TERAGAN & ASSOCIATES, INC. ARBORICULTURAL CONSULTANTS

MEMORANDUM

DATE: October 16, 2021
TO: Emily Meharg (City of Sandy)
FROM: Todd Prager, RCA #597, ISA Board Certified Master Arborist
RE: Tree Preservation and Removal Review for Sandy Woods Phase 2

This memorandum is a summary of my review of the tree preservation and removal plan for the Sandy Woods Phase 2 project.

Figure 1: Typical minimum protection zone

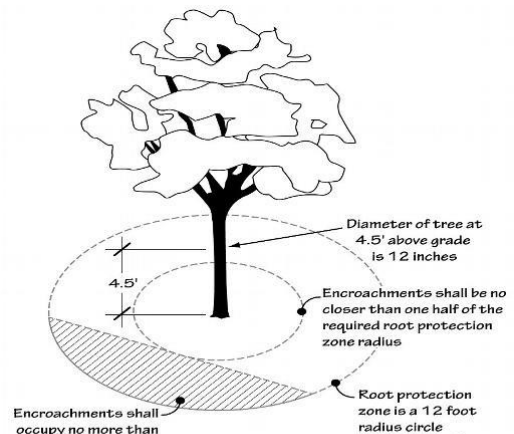
Many of the trees to be retained do not meet the City's administrative tree protection zone shown Figure 1. However, it appears that the trees to be retained can be protected using this standard while allowing for the proposed development of the site by placing tree protection fencing in the locations shown on the plan sheets in Attachment 1.

I recommend that the applicant review the feasibility of the proposed tree protection fencing, and substantively implement the protection zones in accordance with Figure 1. The following items should be addressed if a revised tree protection plan is required:

Site Plan with Retention Trees, RPZ's and Building Footprints

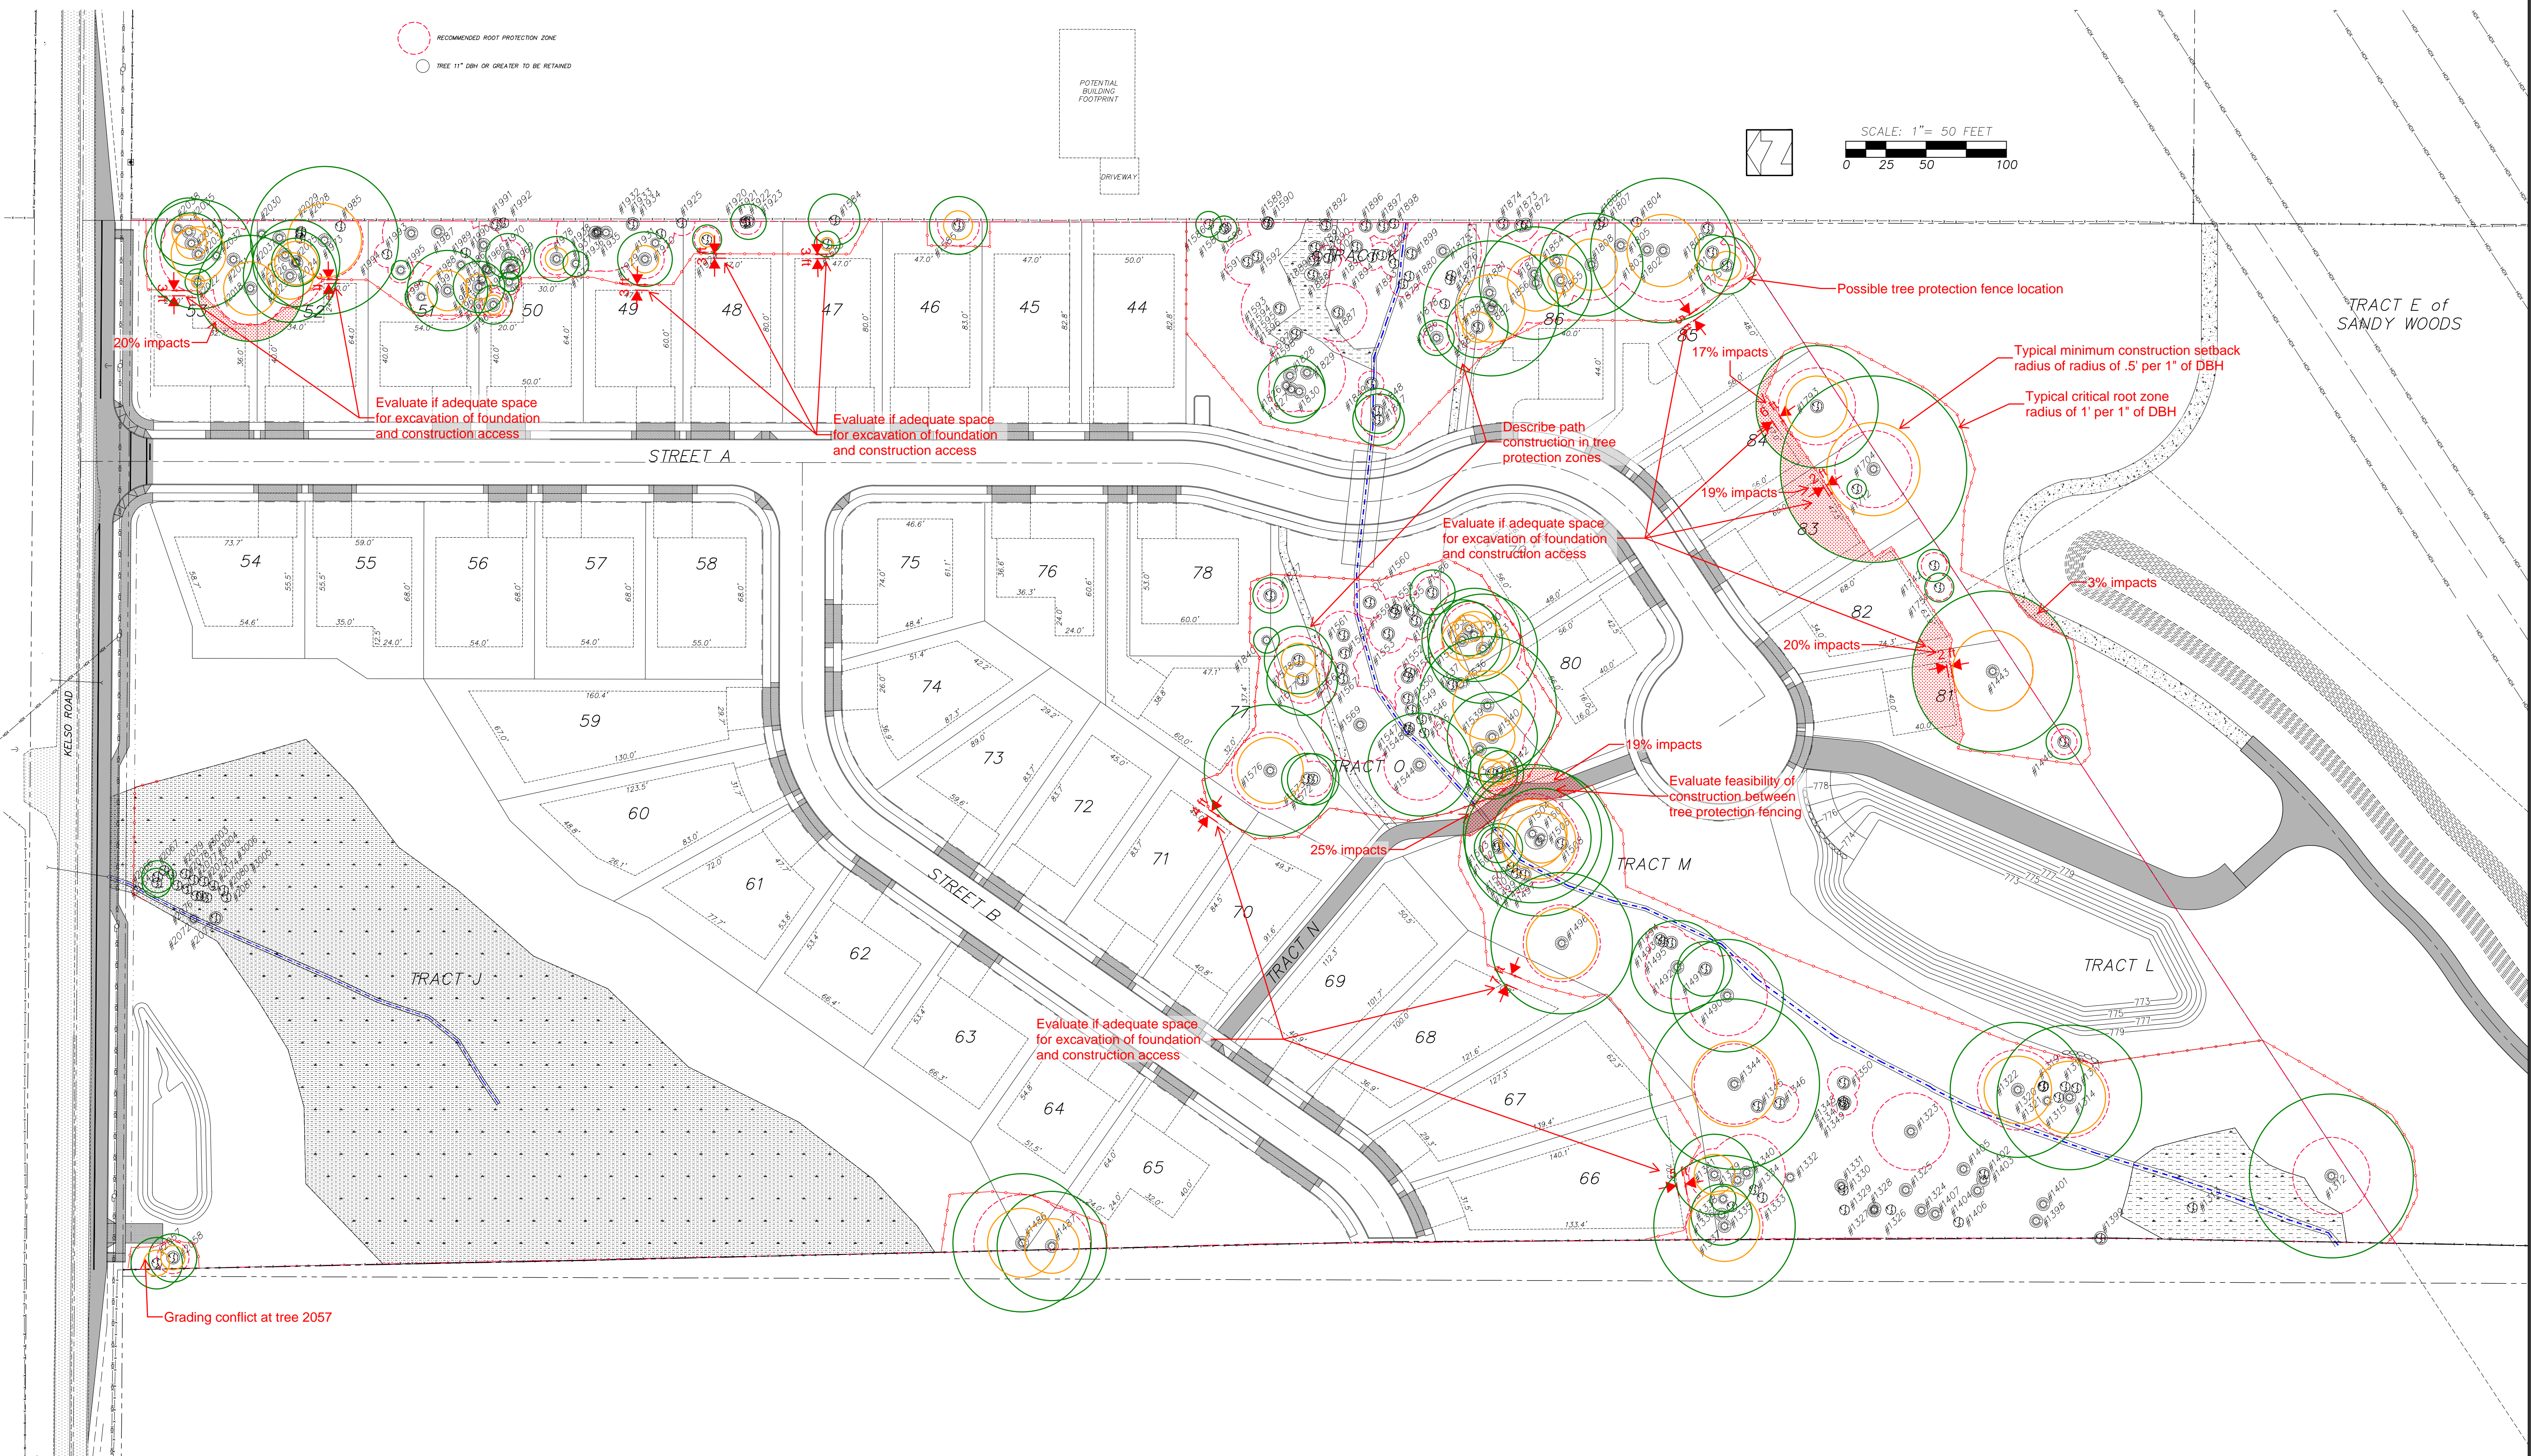
- Evaluate if there is adequate space for excavation of the house foundations and construction access between the proposed houses and tree protection fences on lots 47, 48, 49, 52, 53, 66, 68, 71, 82, 83, 84, and 85 as noted in Attachment 1.

- If there is not adequate space, can building envelopes be reduced to accommodate the tree protection zones? Alternatively, can the tree protection zones be modified to allow for adequate space while providing the minimum protection zones in accordance with Figure 1?

Tree Retention/Removal Plan

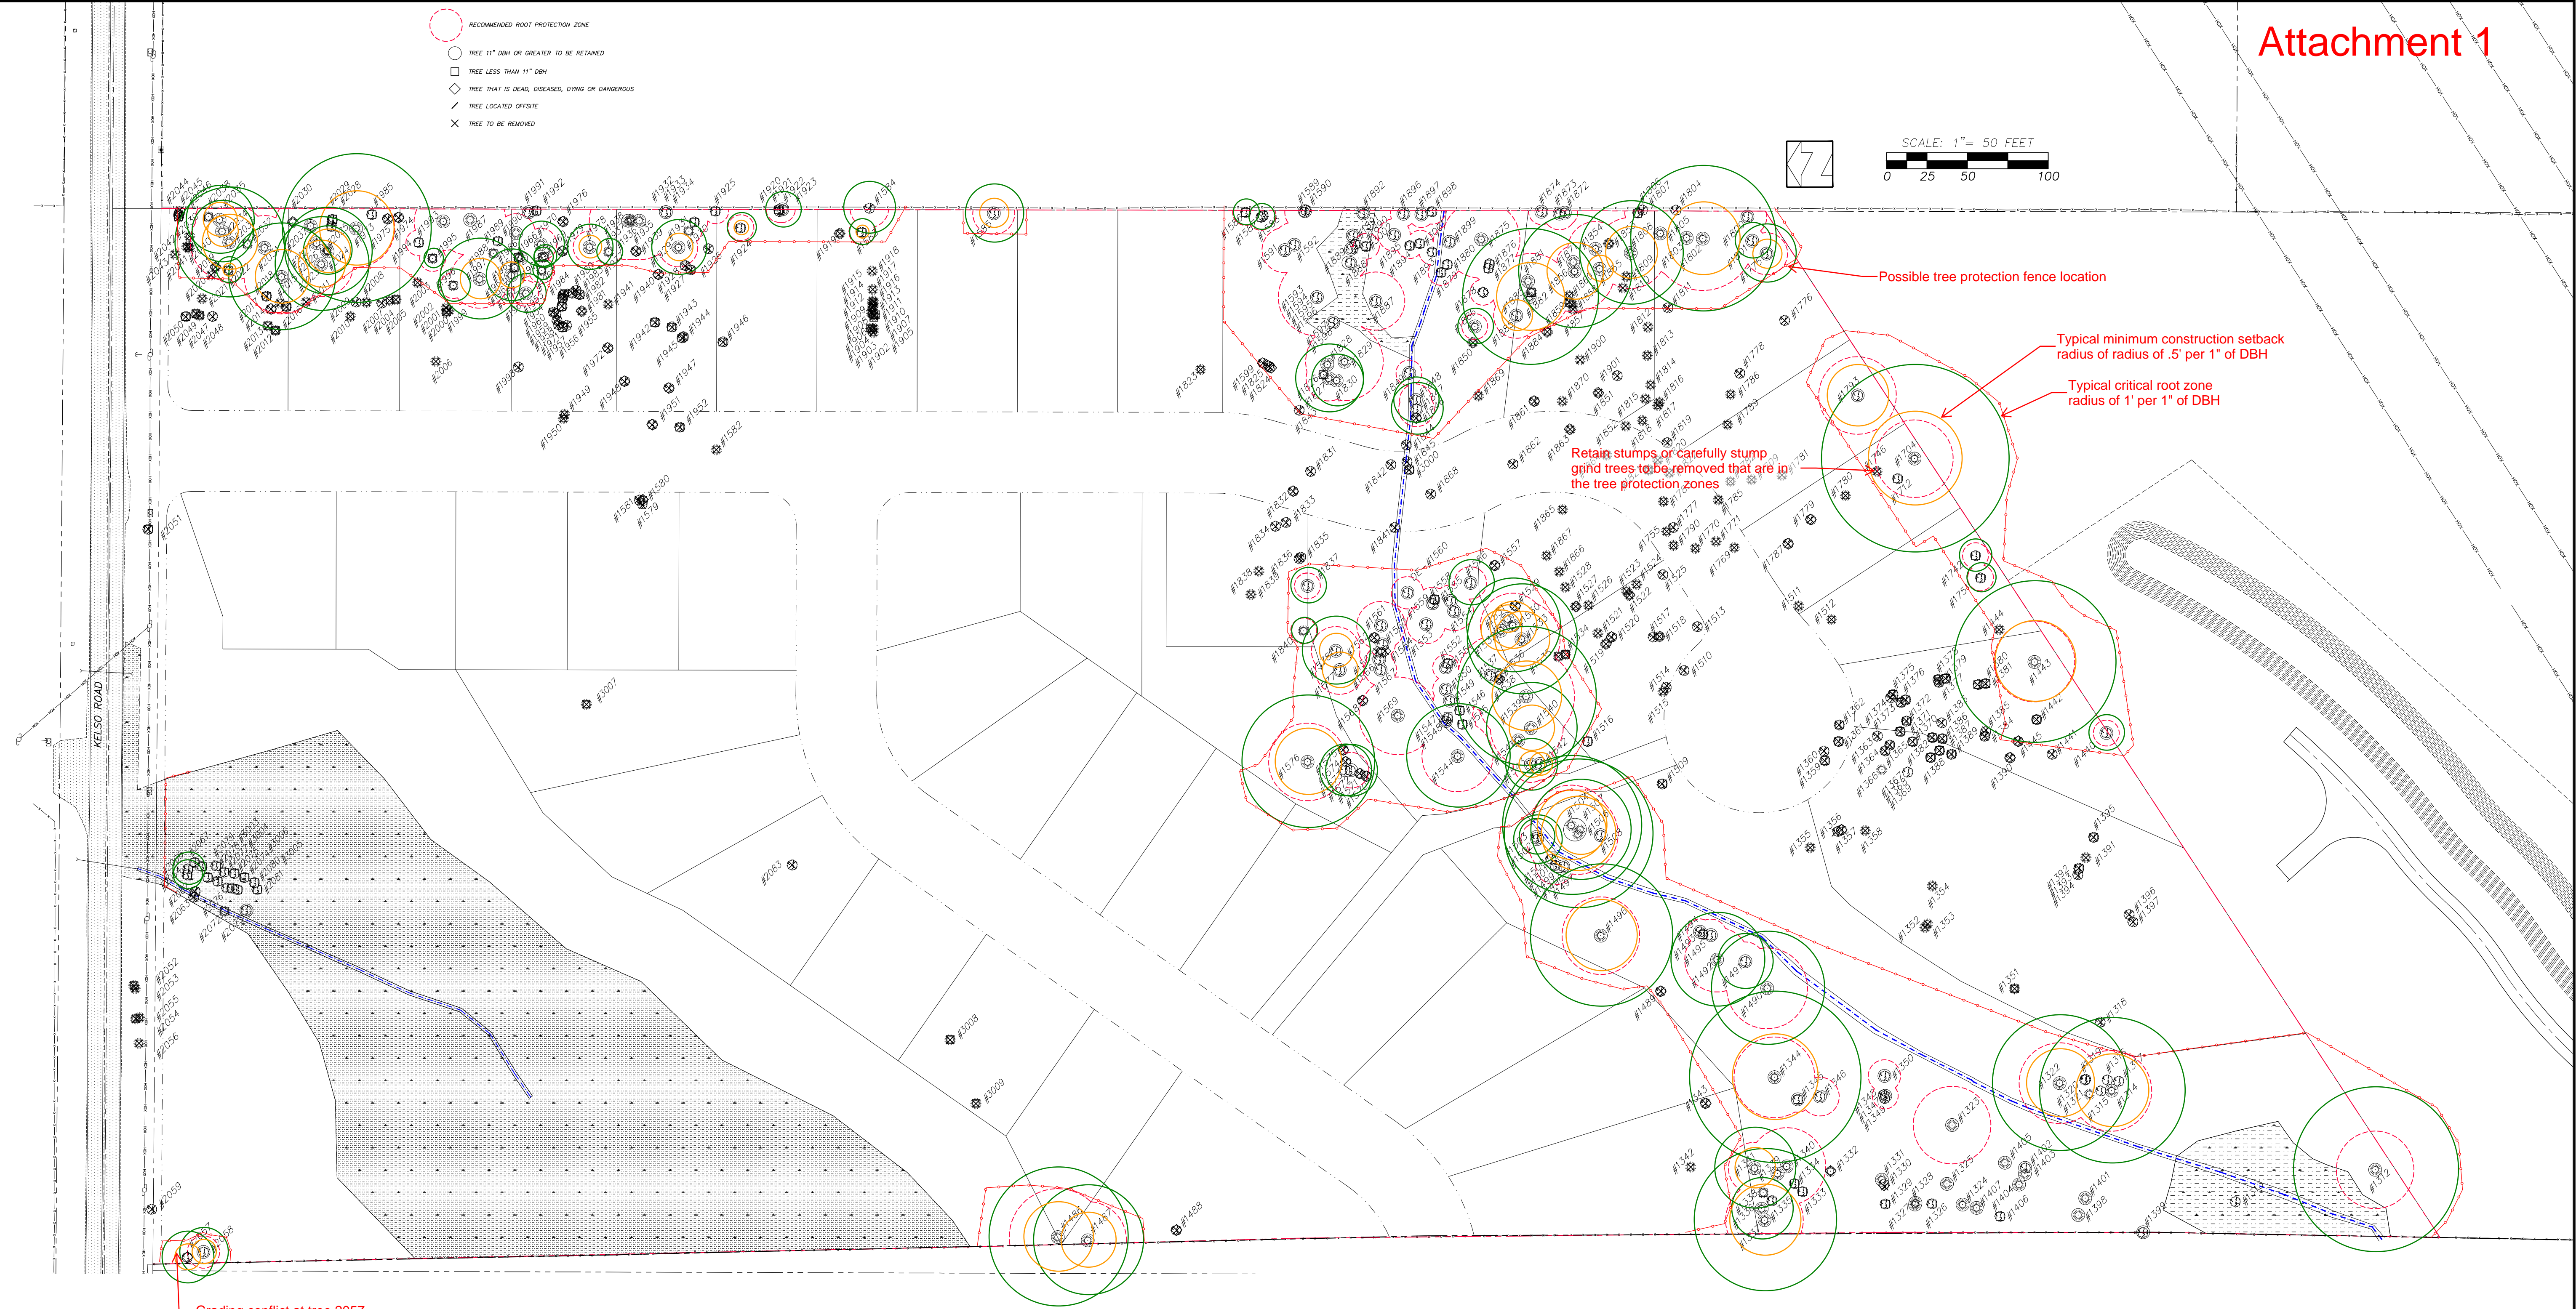
- Will the stumps of trees to be removed that are within the tree protection zones be left in place or carefully stump ground to protect the root systems of the adjacent trees to be retained?

- The proposed grading appears to conflict with the protection zone of tree 2057. Can the grading be adjusted using retaining walls or other strategies to protect the tree in accordance with Figure 1?

Possible tree protection fence location

Typical minimum construction setback
radius of radius of .5' per 1" of DBH

Typical critical root zone
radius of 1' per 1" of DBH

Retain stumps or carefully stump
grind trees to be removed that are in
the tree protection zones

Grading conflict at tree 2057

Onsite Sanitary and Water Plan

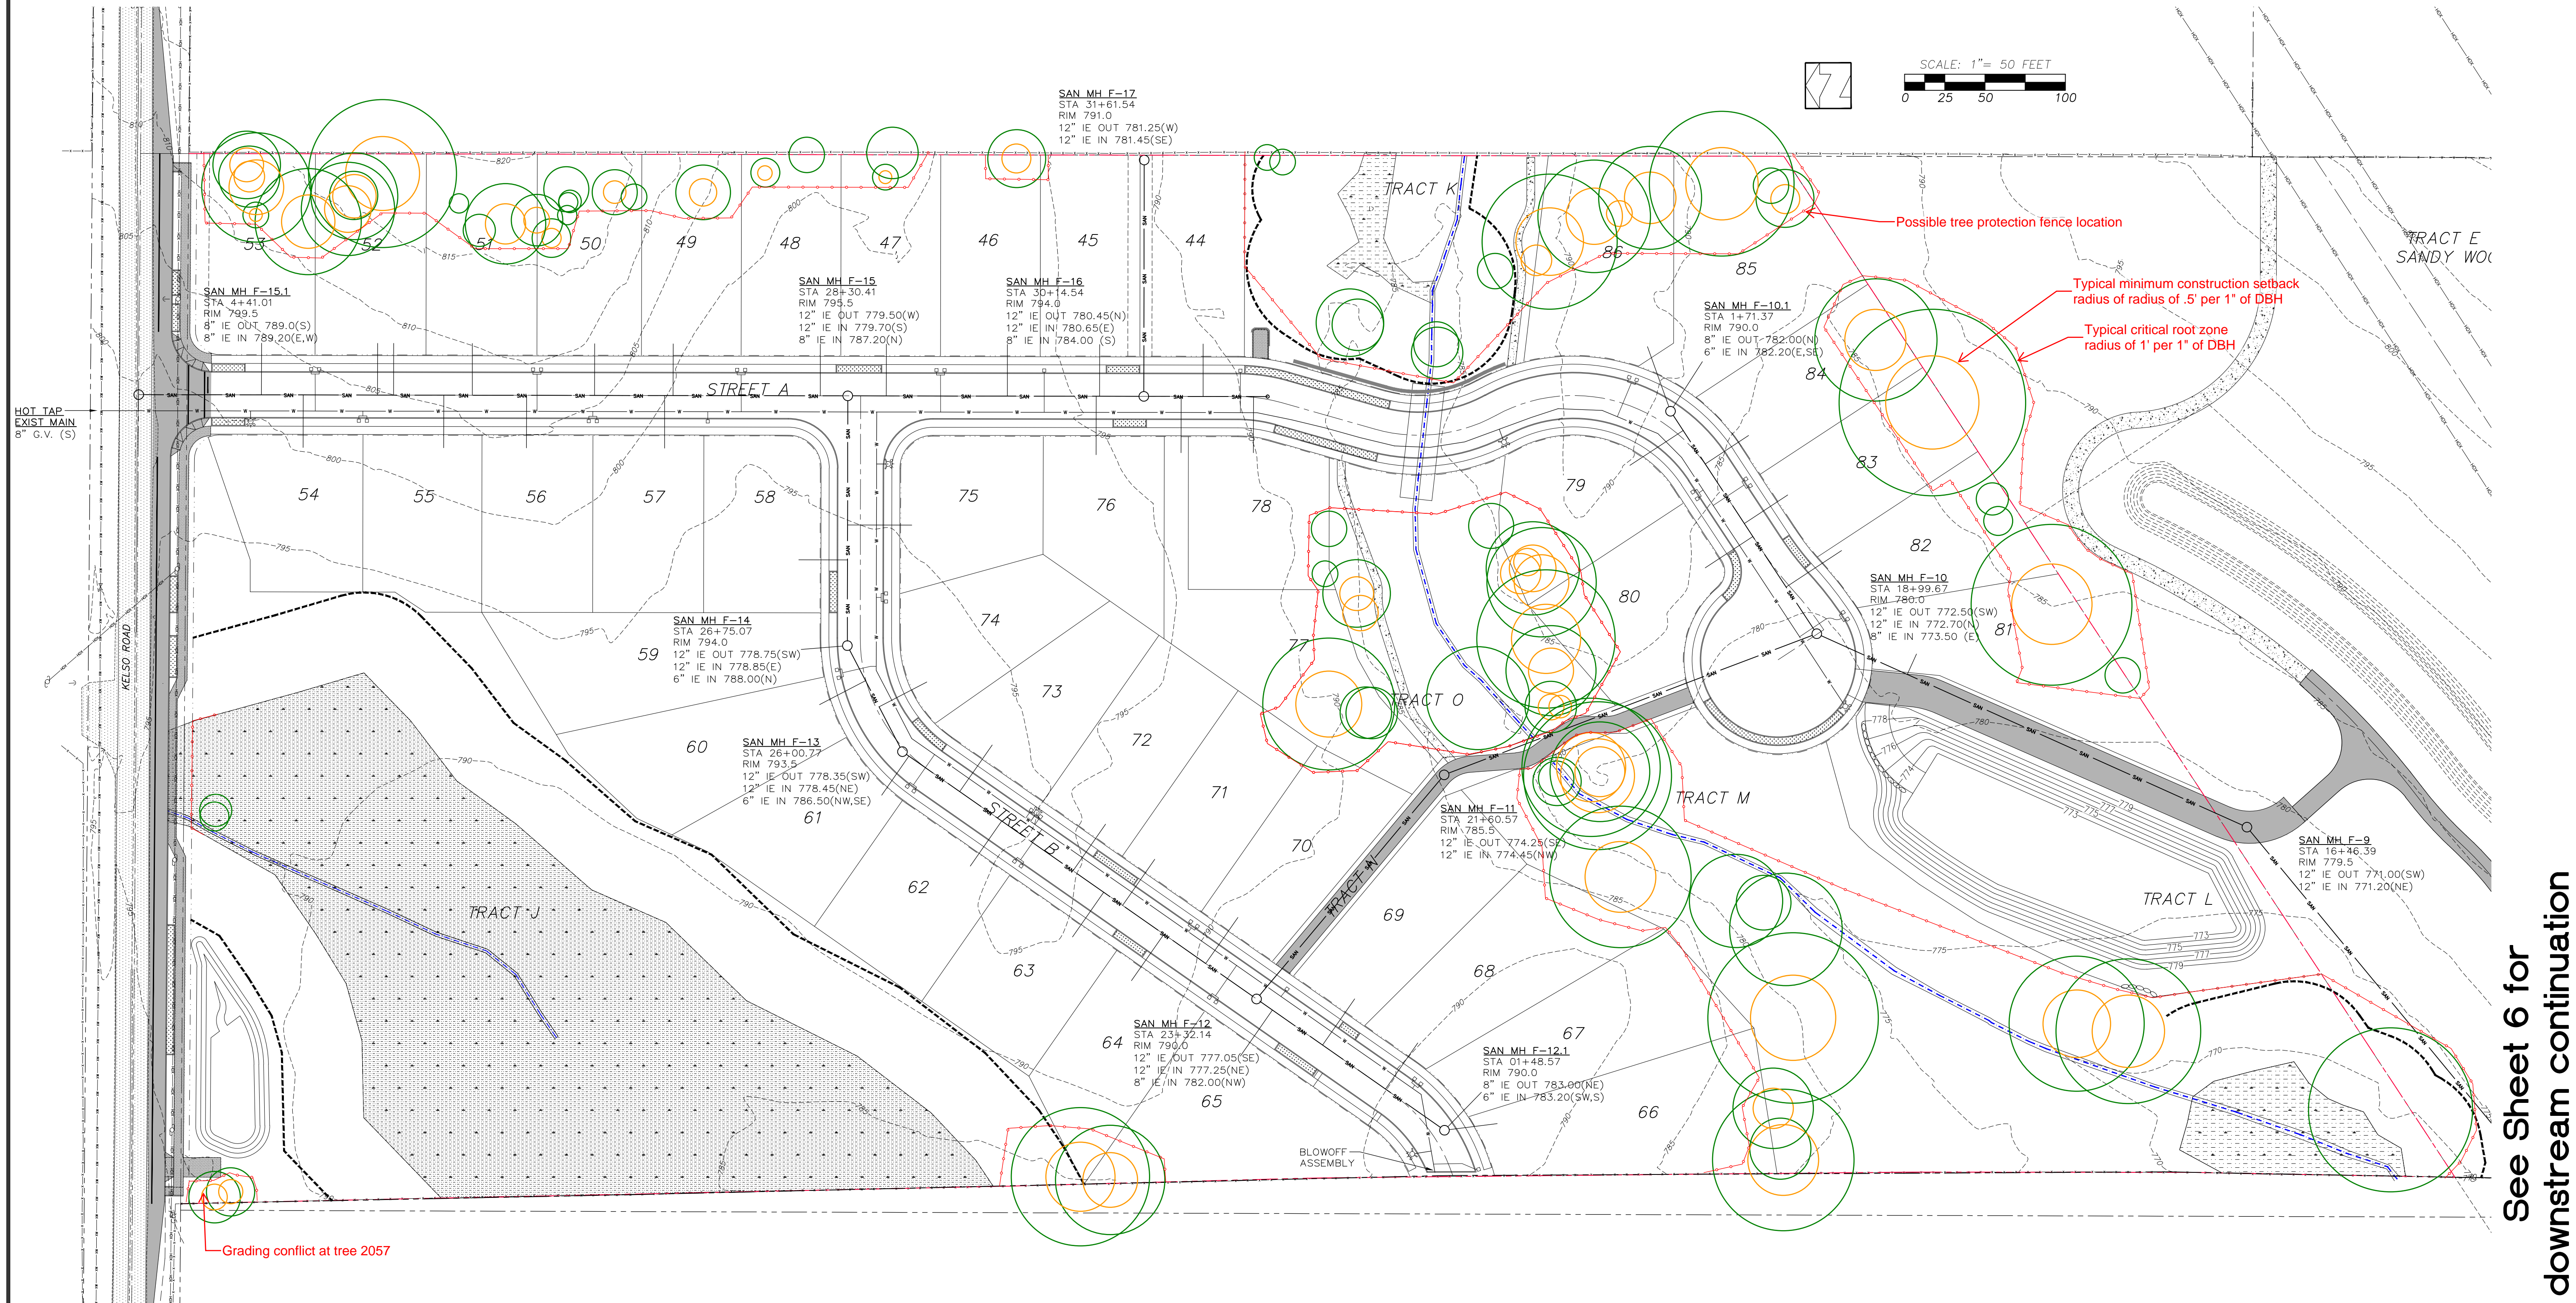
- Evaluate if there is space for sewer line and path construction between trees 1504 and 1542 as noted in Attachment 1. If there is not space, can strategies such as boring and/or reduction of pathway width and associated grading be implemented to protect the trees in accordance with Figure 1?
